## Body Repair Manual Welding & Sectioning Guideline Revisions

(Supersedes original publication, issued **August 2016**, to change the Tool and Equipment Program phone number)

Rear Inner Panel Service Part Example

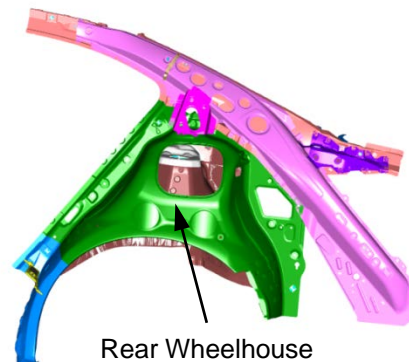
- Replacement of body service parts as supplied at factory seams is the preferred repair method, except when it may cause unnecessary or excessive intrusion into the body structure.
- In these cases, the service part may be disassembled at factory seams as required to replace only the damaged portion.
- For example, if only the vehicle's rear wheelhouse is damaged, that part may be removed from the rear inner panel service part assembly at the factory seams and installed on the vehicle.
- Note that there is **not** a BRM replacement procedure for rear inner panels because they are rarely installed as a complete unit.
- All basic welding & sectioning guidelines specified in the service information **must** be observed during partial panel replacement.

Sectioning Area Examples

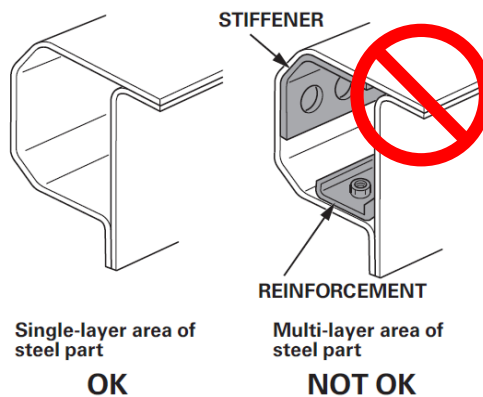
- Outer body and floor panels may be sectioned as necessary. Specific sectioning procedures are not provided in the BRM.
- Depending on the type of vehicle damage, steel parts with a tensile strength of 780 MPa or less may be sectioned **if all three of the following conditions are met:**

1. Sectioning must be done in a single-layer area of the part.
  2. Multi-layer internal steel reinforcements and stiffeners must not be cut.
  3. Do not section in load bearing areas, such as engine, transmission, or suspension mounting points.
